SUPPLEMENTAL RESPONSE TO REQUEST FOR ADDITIONAL INFORMATION

APR1400 Design Certification

Docket No. 52-046

RAI No.: 92-8068
SRP Section: 03.09.05 – Reactor Pressure Vessel Internals
Application Section: 3.9.5
Date of RAI Issue: 07/21/2015

Figure 6-2 Design of CEA Guide Tube to Fuel Assembly

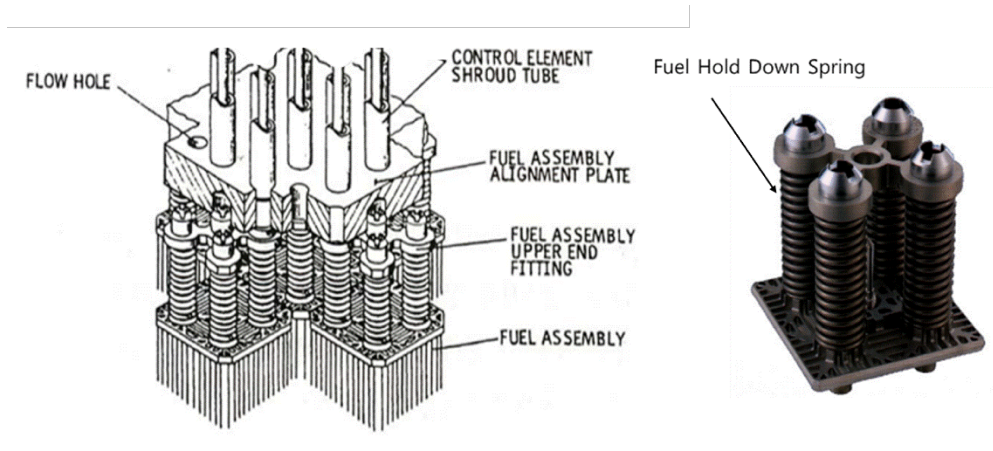
2. The staff also requests additional information about design provisions that would prevent misalignment from the fuel assembly guide posts and its impact on the control element guide tubes and insert tubes after each refueling outage. According to the letter referenced above, after the core is defueled and refueled, a total of 964 tubes (both the control element guide tubes and insert tubes) need to fit into the fuel assembly guide posts when the UGS assembly is lifted and put back into the reactor vessel, on top of the fuel assemblies. If there is any misalignment, the bottom end of these control element guide tubes or insert tubes could be pitched or crimped without any indication. This not only could potentially damage the fuel assemblies due to excess compressive force exerted on them, but in the case of a fuel assembly with control element guide tubes, this could also prevent the CEA from inserting into the fuel assembly if a control element guide tube is

- o Analyses performed for the control element guide tubes and insert tubes in terms of how the structural integrity can be maintained throughout its design life
- o Design provisions to address any misalignment issue during refueling outages when the UGS assembly is put back into the reactor vessel
- o Design provisions to ensure that a similar incident to the Palo Verde event stated above, or other significant operating experience related to reactor internals, will not occur in the APR1400 design
- o Inspection results from similar operating plants that address these issues

The true position requirement for the fuel assembly guide post is determined by taking the allowable CEA guide tube to fuel assembly guide post offset and subtracting the positional tolerance stackups between the fuel assembly center post and the fuel assembly outer guide post centerline, and between the CEA guide tube centerline and the Lower Support Structure/Core Shroud centerlines. The allowable CEA guide tube to fuel assembly guide post offset represents the maximum offset between the centerlines of the CEA guide tube and fuel assembly outer guide post which will permit the chamfered surfaces of the tube and post to engage as shown in Figure 6-1. Therefore, the design accounts for the tolerance to allow for insertability. During re-assembly after refueling, it is the responsibility of the licensee to perform a visual or some confirmation that there is no binding or obstruction that could impact insertability.

The worst horizontal deflection of the CEA guide tube is evaluated in accordance to the ASME Code during level D conditions. The maximum deflection of the guide tube is compared with 80% of the allowable offset of the CEA guide tube. In the APR1400 design, the fuel hold down springs provide a vertical force to prevent vertical movement of the fuel relative to the CEA guide tube during level D conditions. Therefore, there is no vertical deflection of the fuel

assembly guide post relative to the CEA guide tube.
